# CENTRAL 70 PROJECT

Public Disclosure Administrative and Technical Proposal:  
5280 CONNECTORS

VOLUME 2 | Electronic Copy | Binder 8 of 8

<b>2.2</b>	<b>Alternative Technical Concepts (ATCs)</b>	
2.2.1	ATC 2.3 Colorado Interchange DDI .....	Binder 8
2.2.2	ATC 4.2 Storm Sewer Diversion.....	Binder 8

I-70 EAST ATC 25.2 EXHIBIT 2 PRE/POST PROJECT DRAINAGE BASIN		
Designer: XXXXXXXX	Structure Numbers	X-XX-XX
Detailer: XXXXXXXX	Numbers	X-XX-XX
Sheet Subset: _SG	Subset Sheets: _SN	of _SO

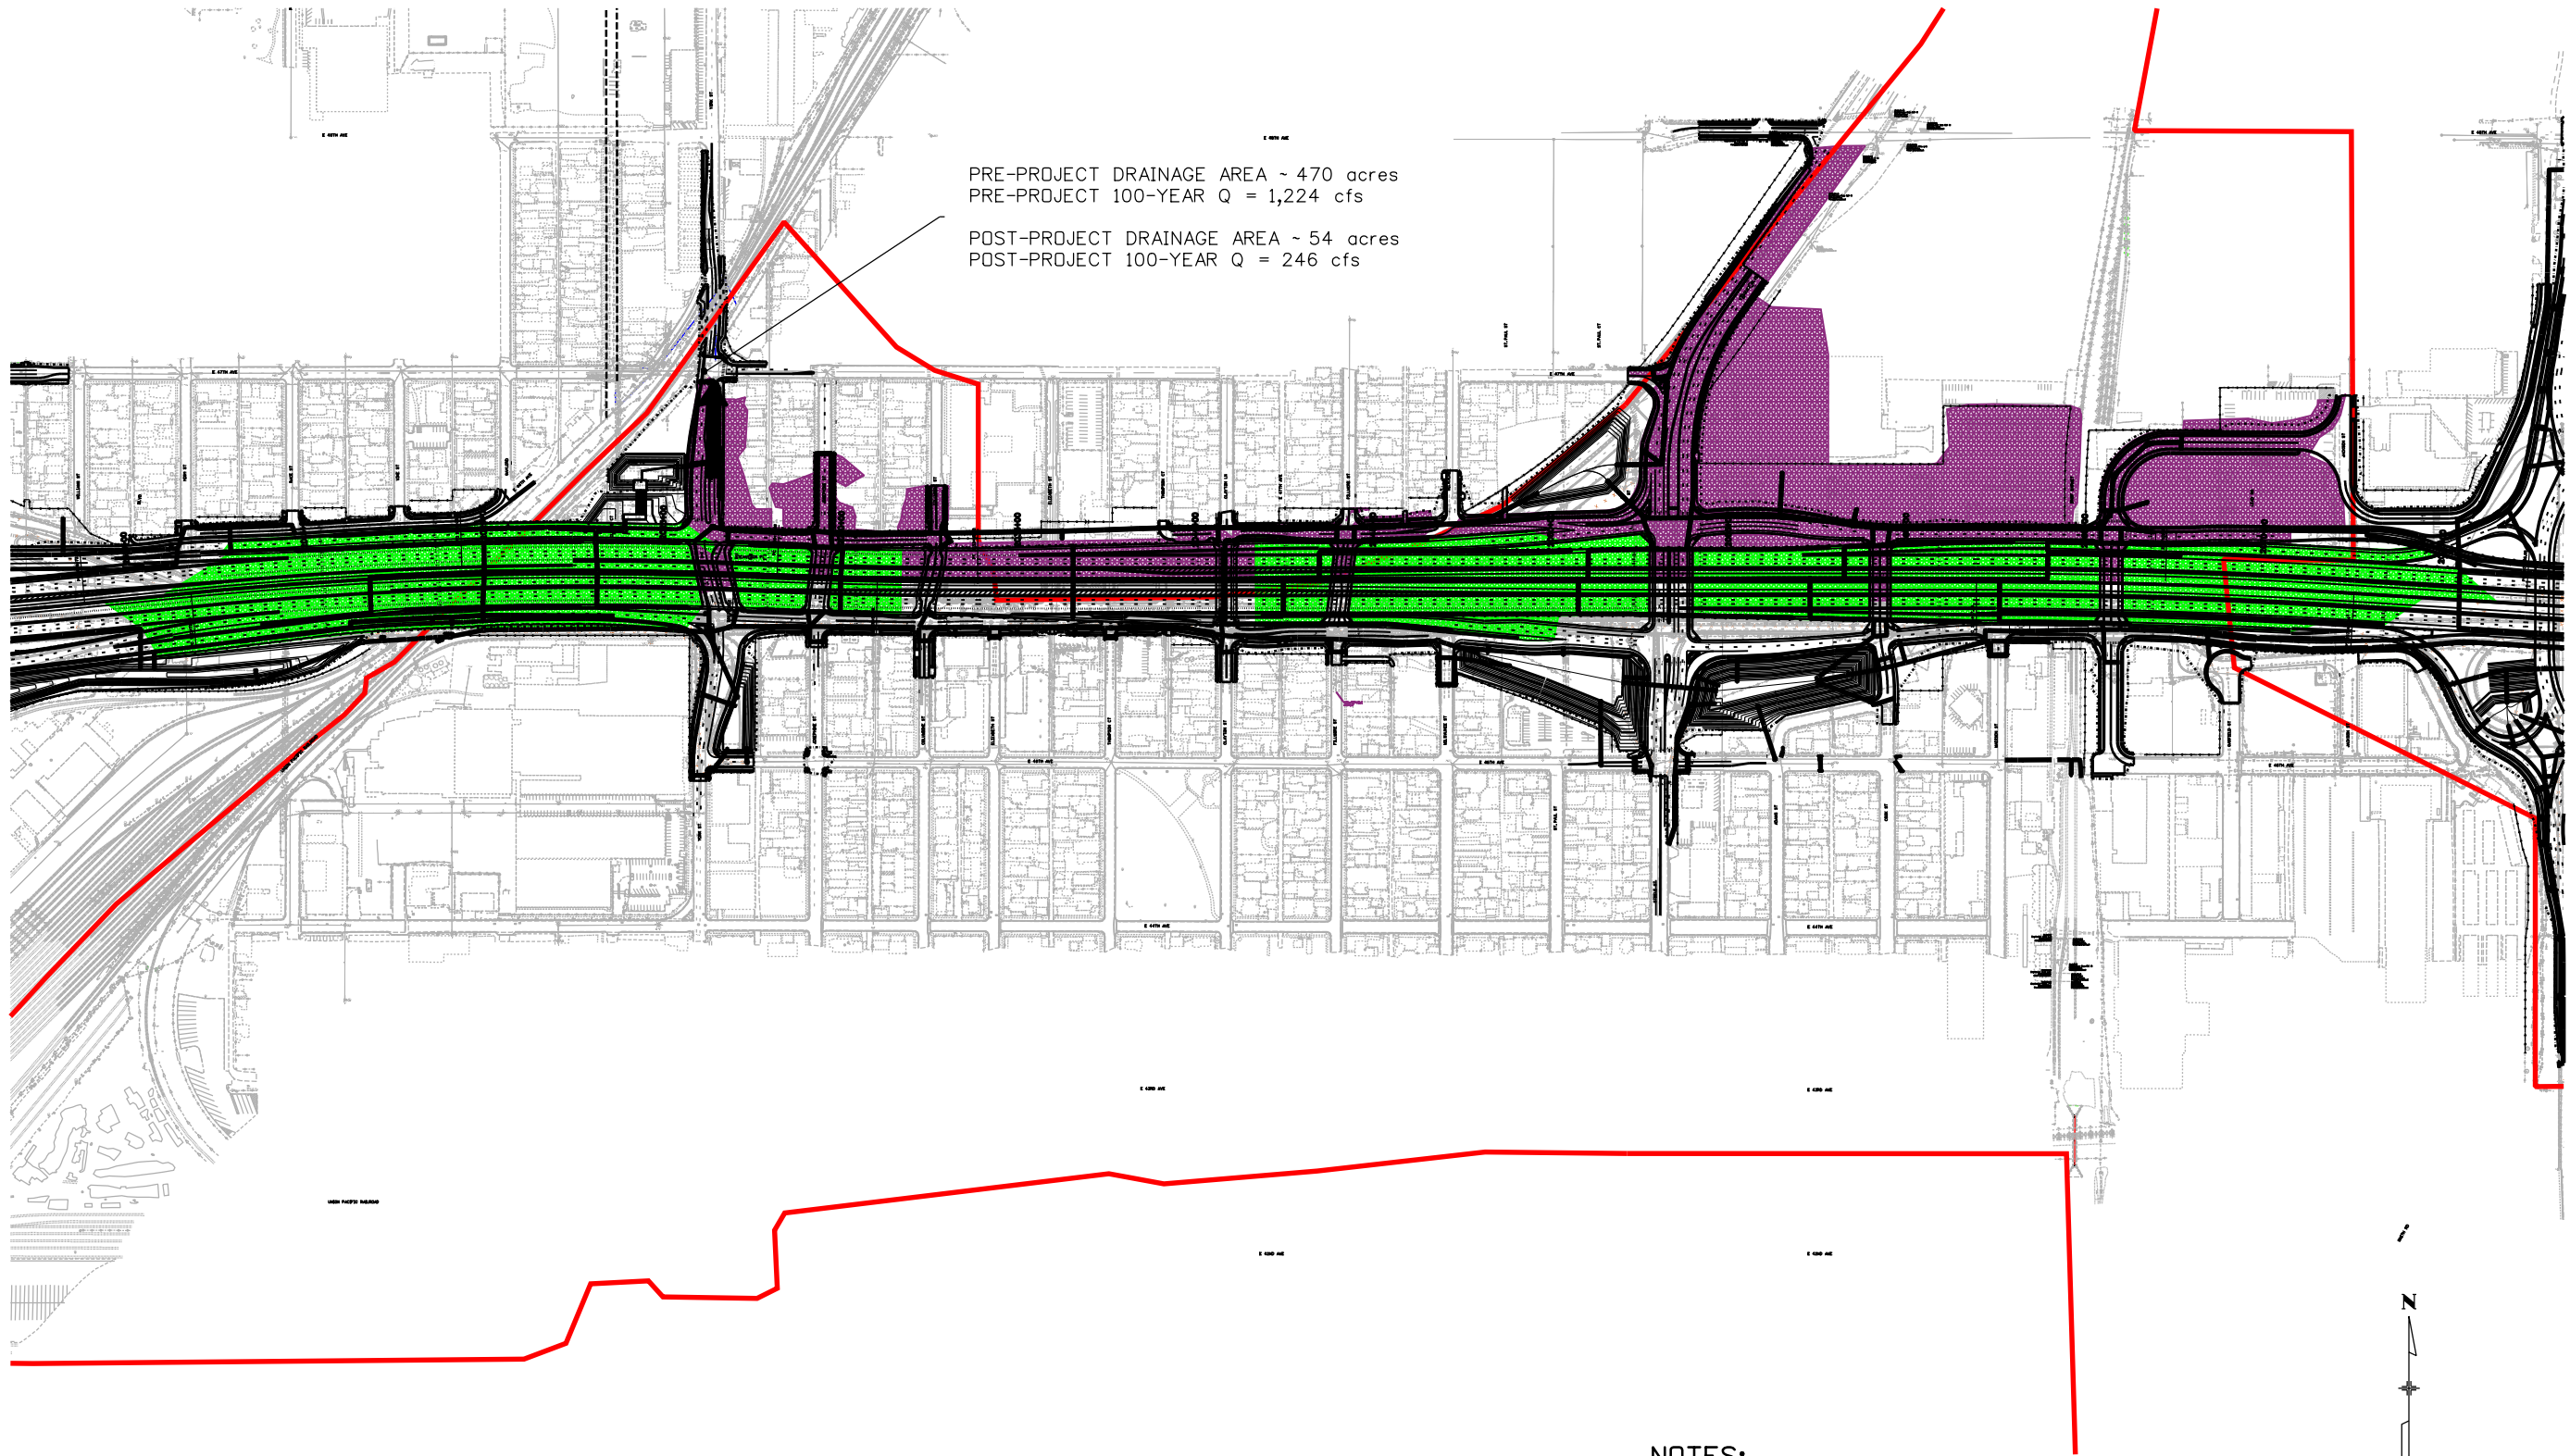
PRE-PROJECT DRAINAGE AREA ~ 470 acres  
 PRE-PROJECT 100-YEAR Q = 1,224 cfs  
 POST-PROJECT DRAINAGE AREA ~ 54 acres  
 POST-PROJECT 100-YEAR Q = 246 cfs

I-70 EAST ATC 41.1 Cover Plan Exhibit	
Designer:	Structure Numbers
Detailer:	
Sheet Subset:	Subset Sheets: 1 of 2

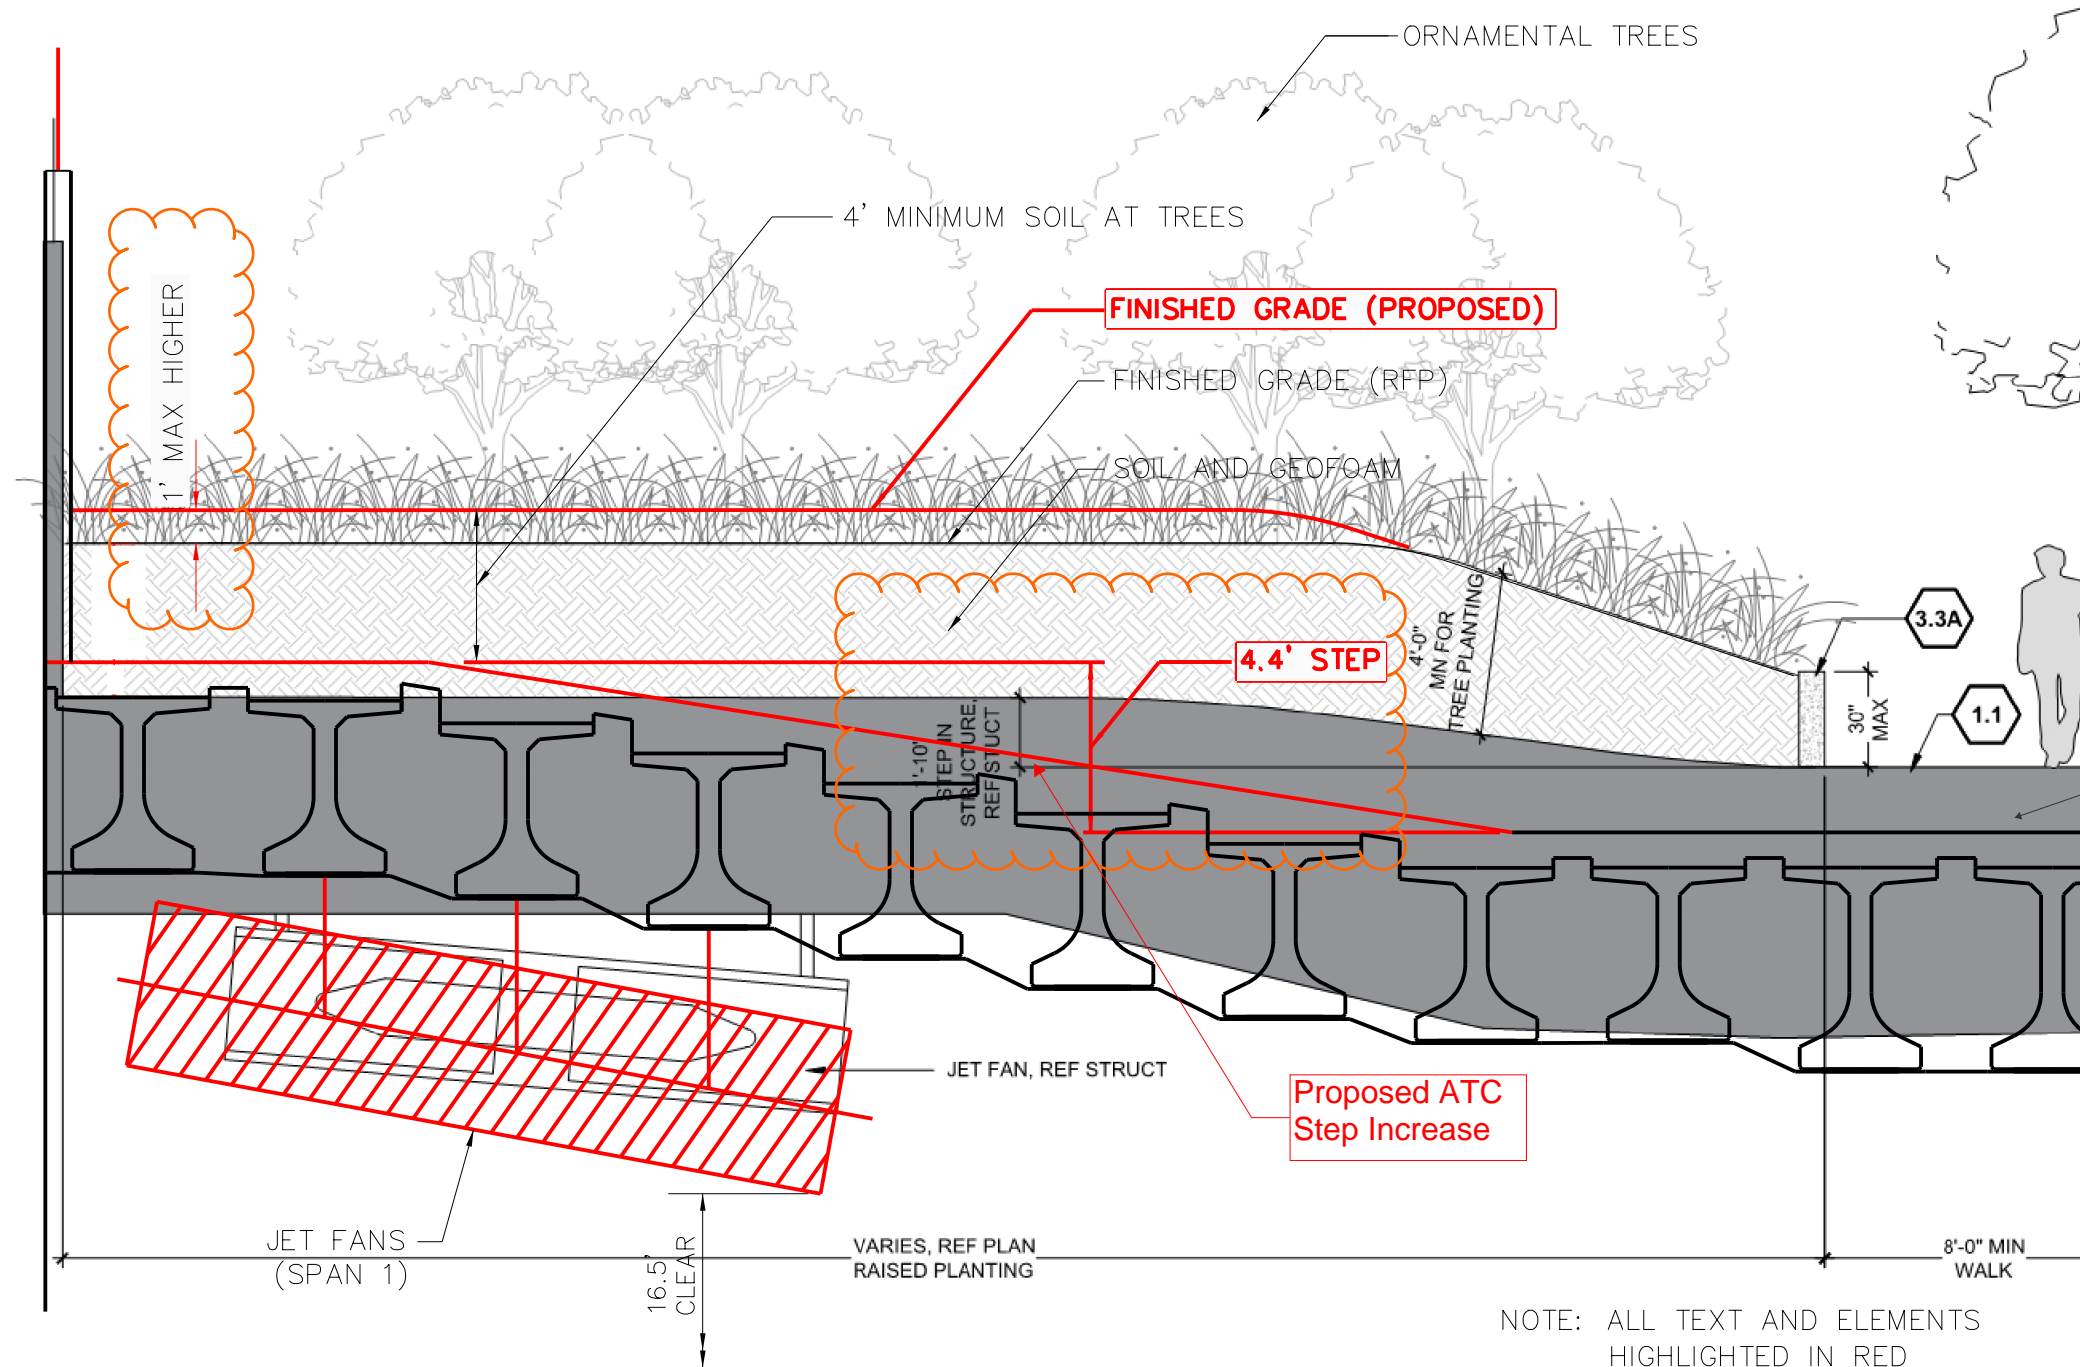
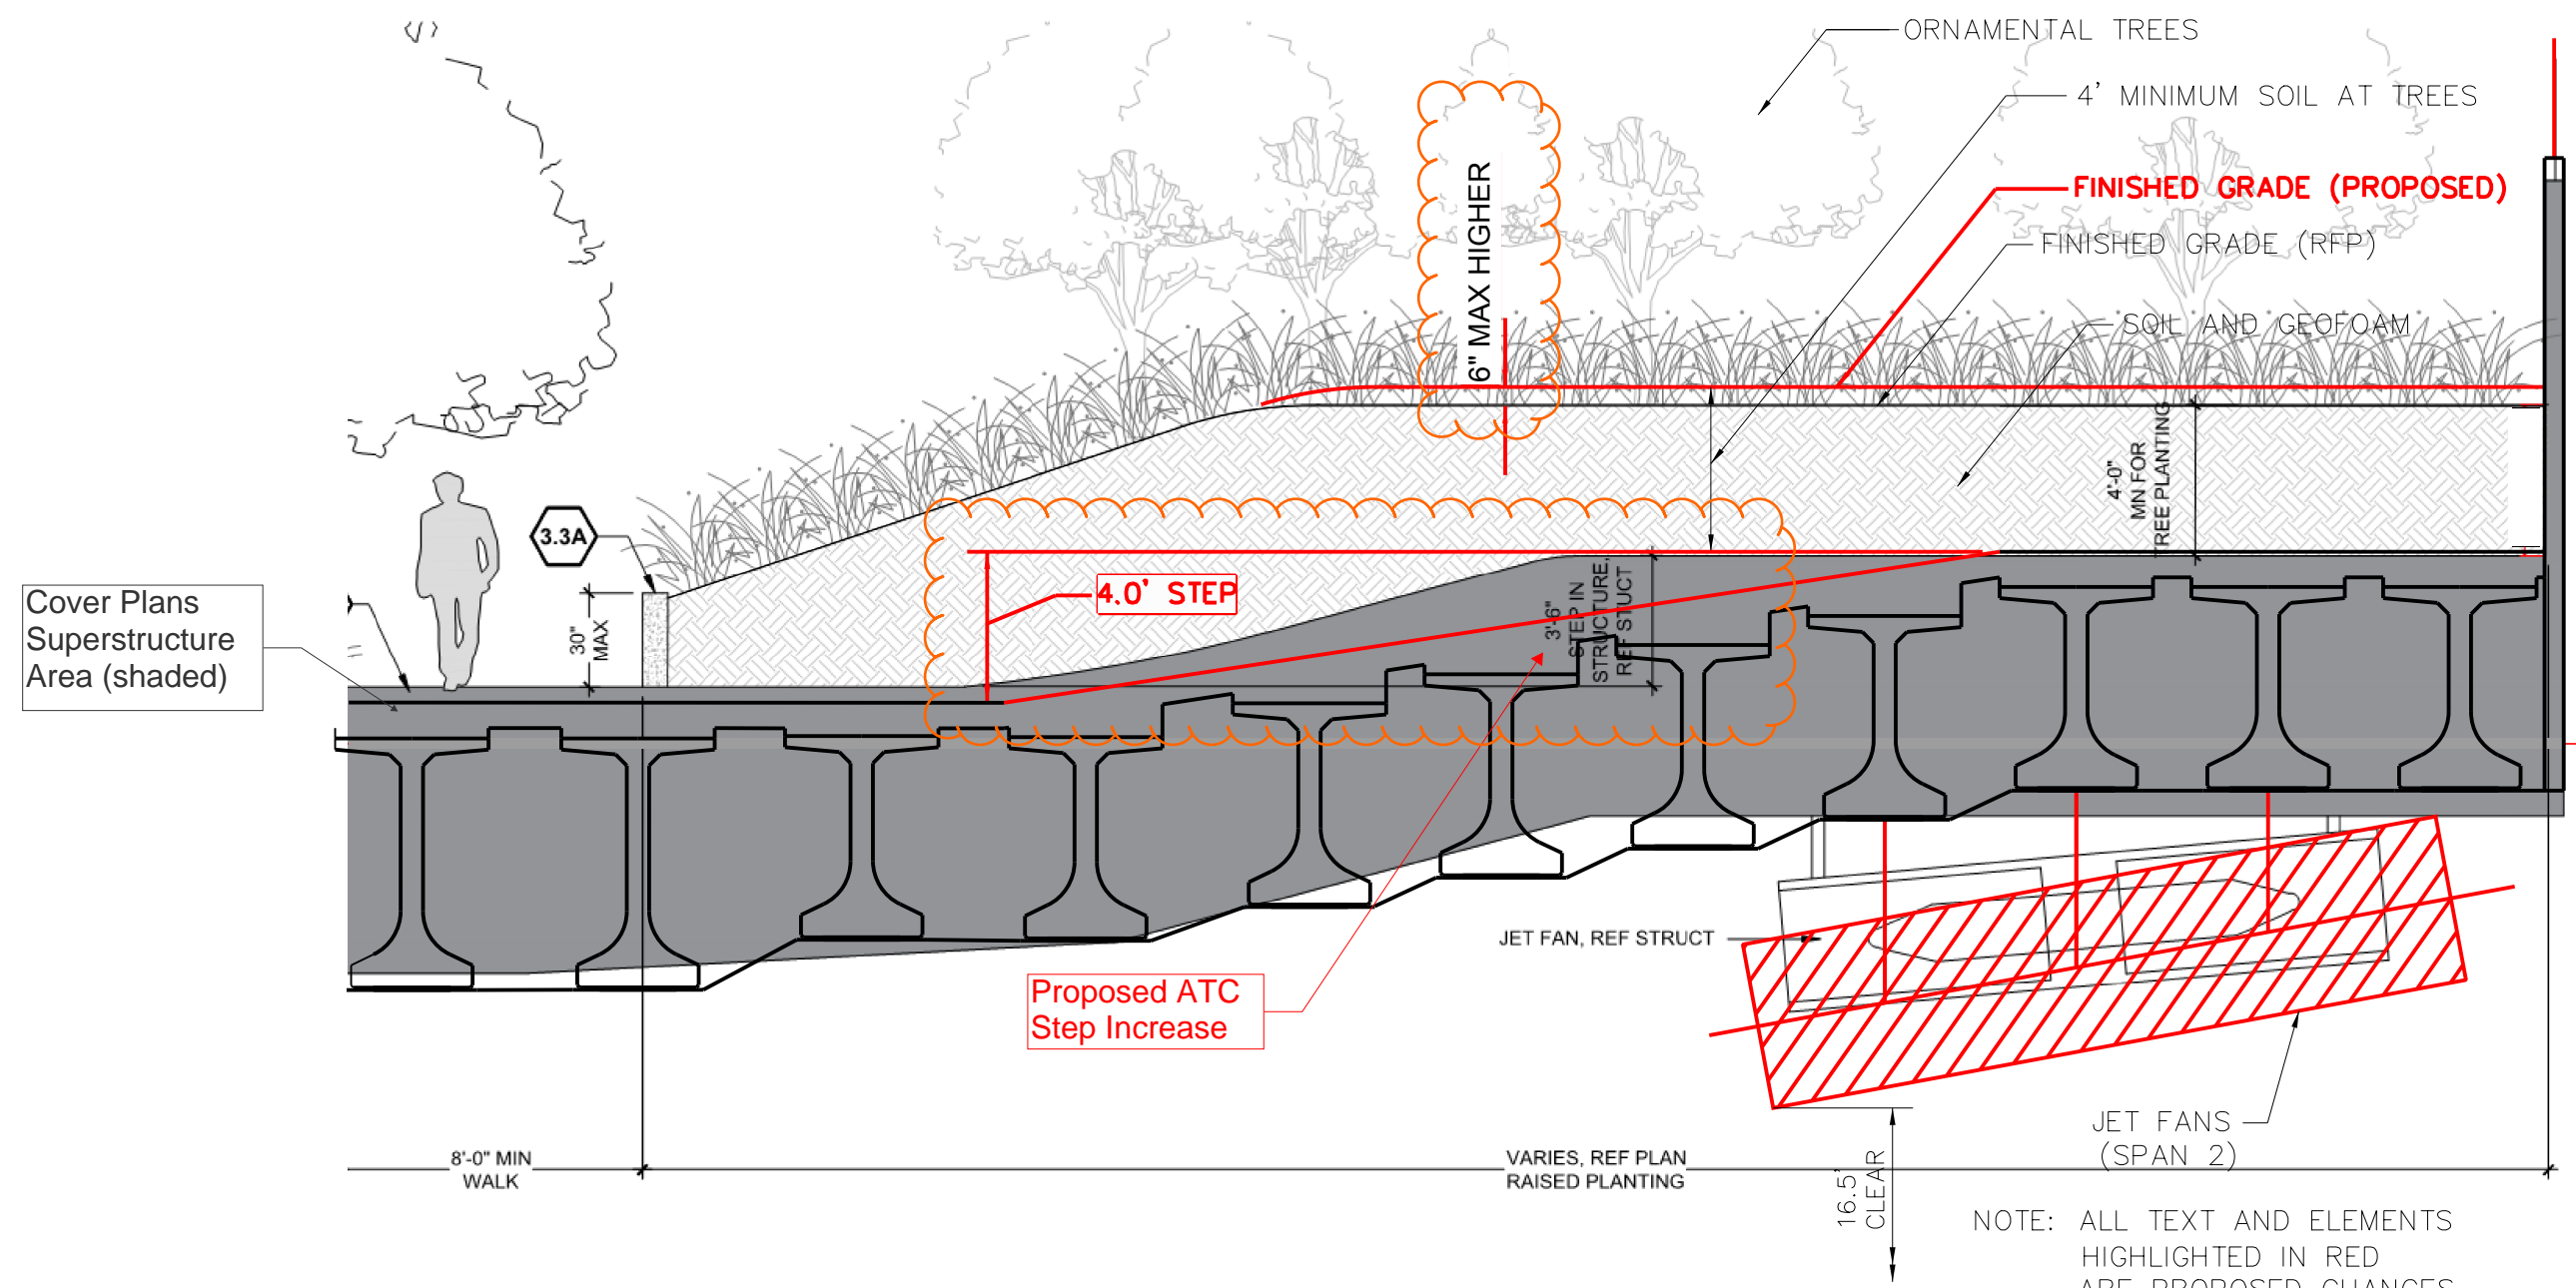
Revisions to the I-70 Cover Plan Contract Drawings 10B.10.14.01 are required for the Columbine and Clayton St. Cover Extenuations for the vertical dimension step at the Portal ends as shown in ATC 41.1 Exhibits.
